**From:** Robert G Jones  
**Sent:** 01 August 2016 21:32  
**To:** Programme Officer  
**Subject:** Examination Library Part 2

### **WESTBRIDGE PARK, STONE – FLOOD RISK ASSESSMENT CONSULTATION RESPONSE.**

# Flood Map for Planning (Rivers and Sea)

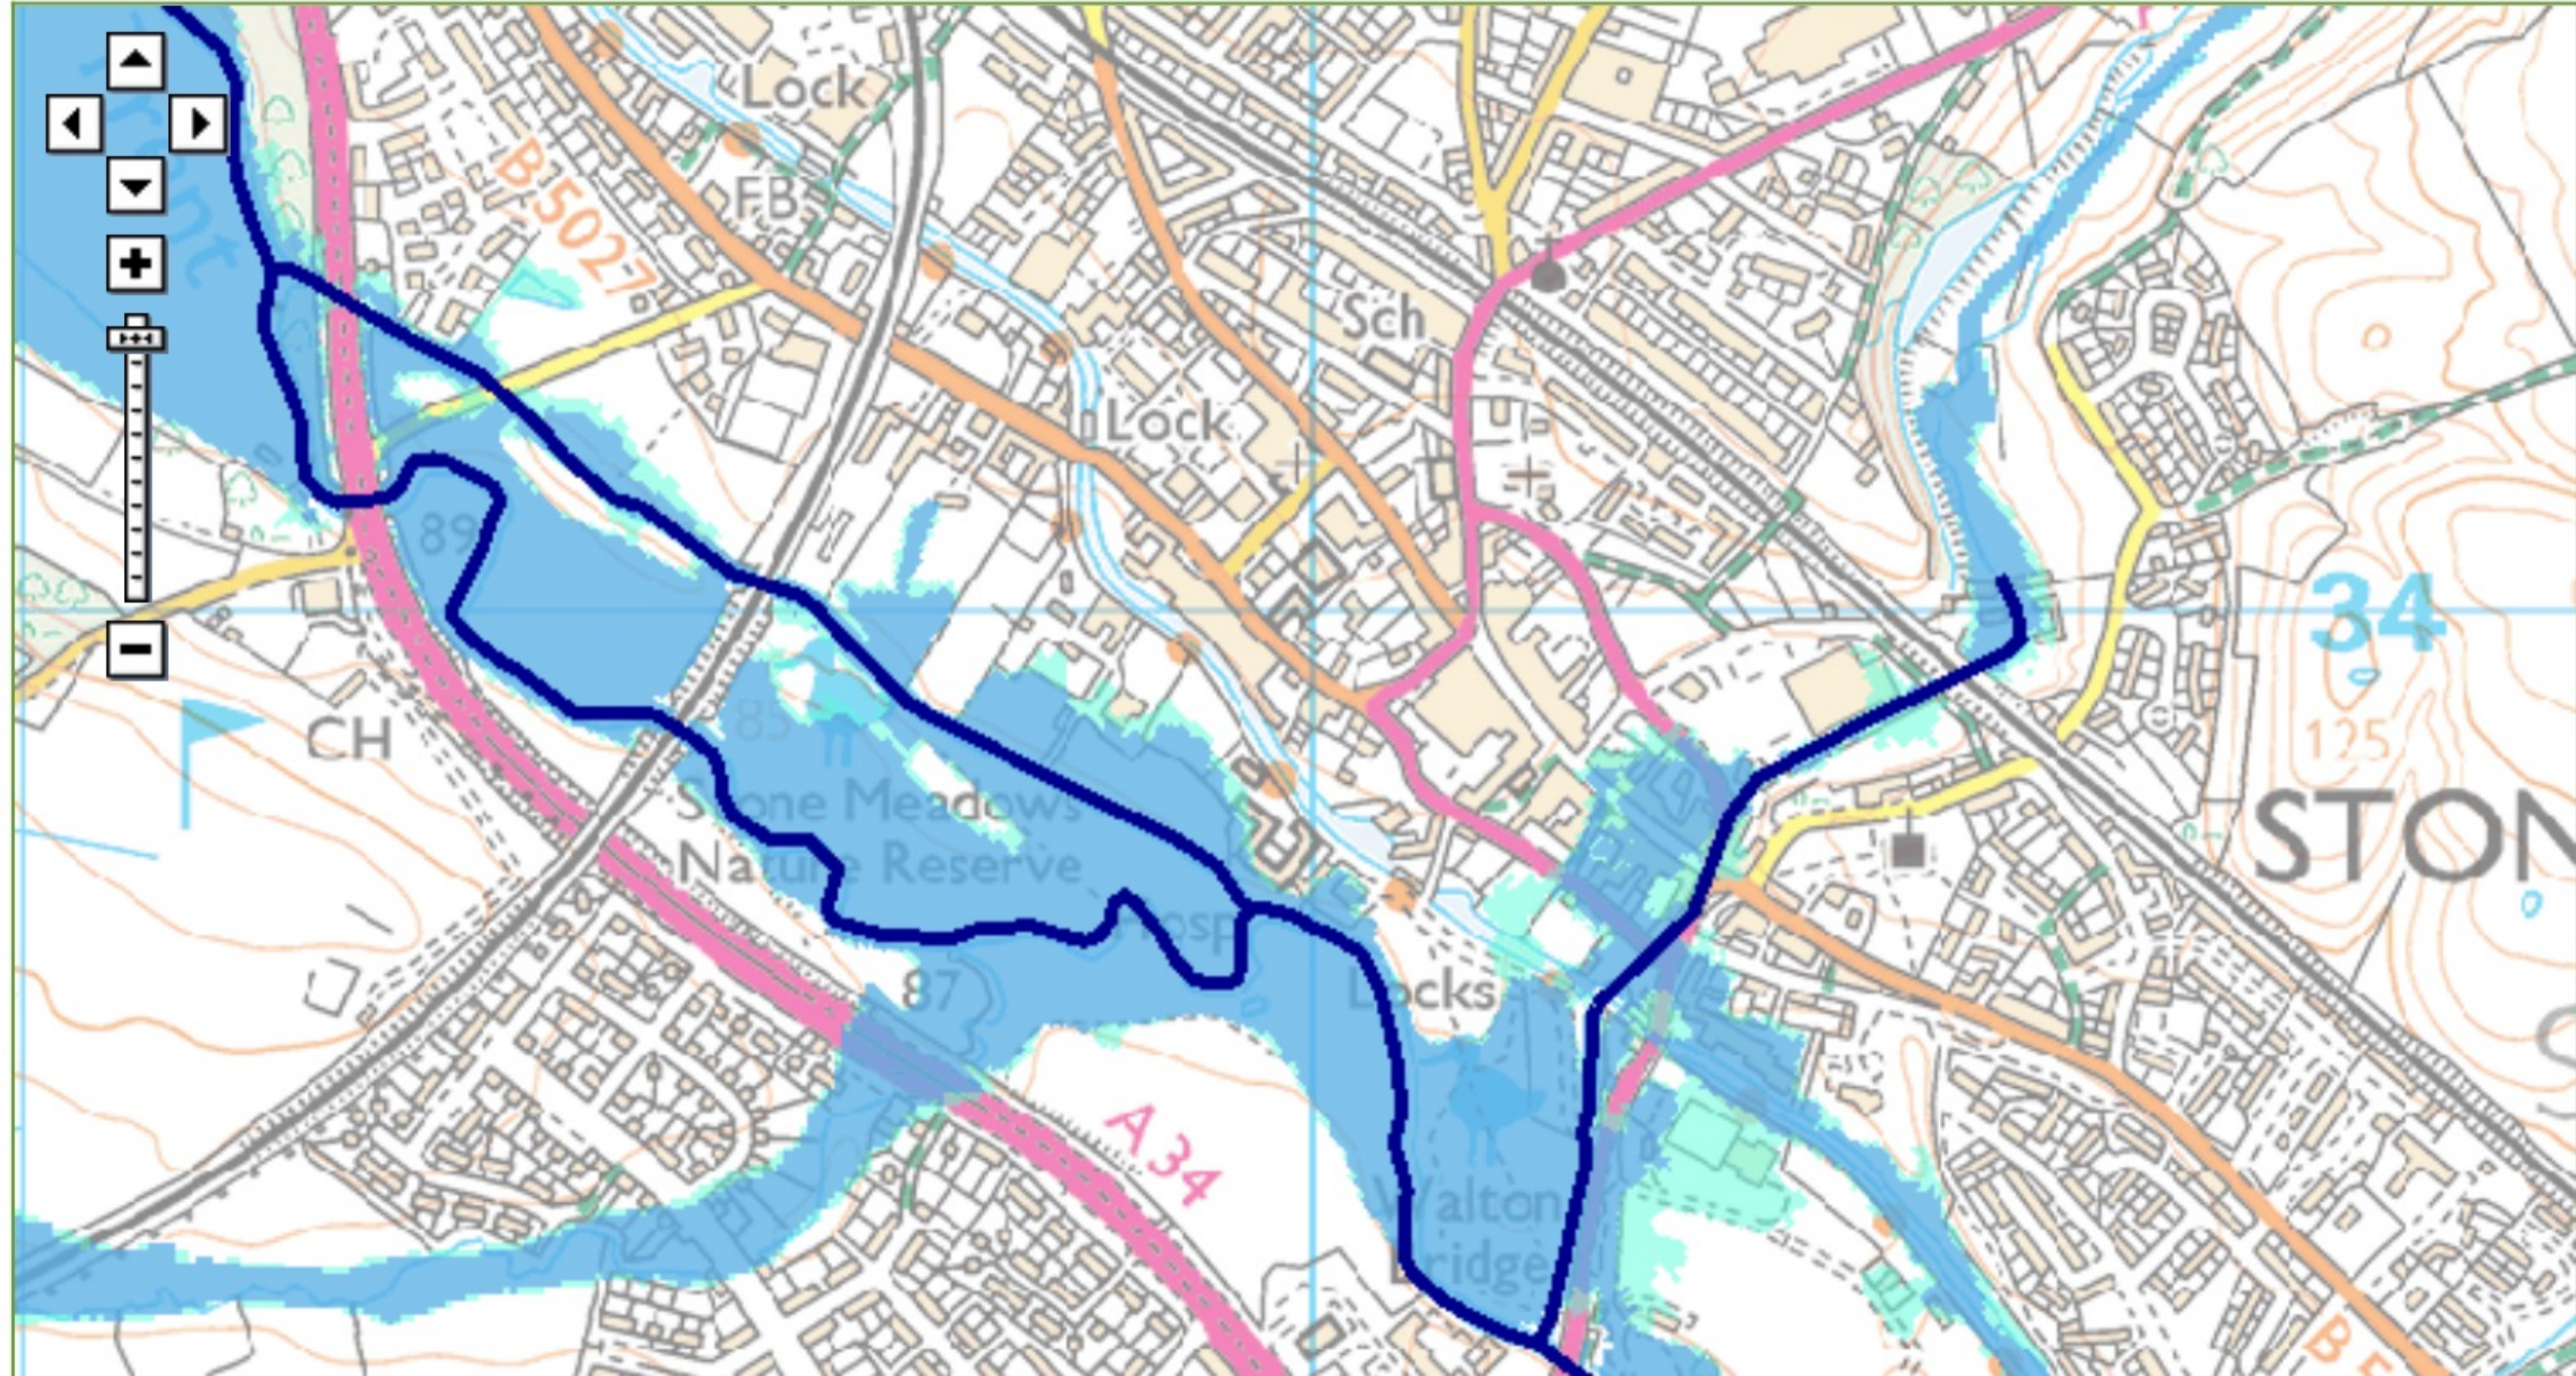
The letter states that " fundamentally " the site is in zone 1 ( flood risk). An Oxford dictionary definition of fundamentally is " used to make an emphatic statement about the basic truth of something" . The Environment Agency on their website for the general public clearly indicates the site for the food store to be in zone 2 and some in zone 3. This appears to contradict the statement made by BWD. Evacuation plans are usually not required for a zone 1 flood zone but the Environment Agency clearly shows the need for such procedures , required for zone 2 and zone 3. I would appreciate it if you would forward my concerns to Mr Fox about the accuracy of the BWD letter to Mr Dolman.
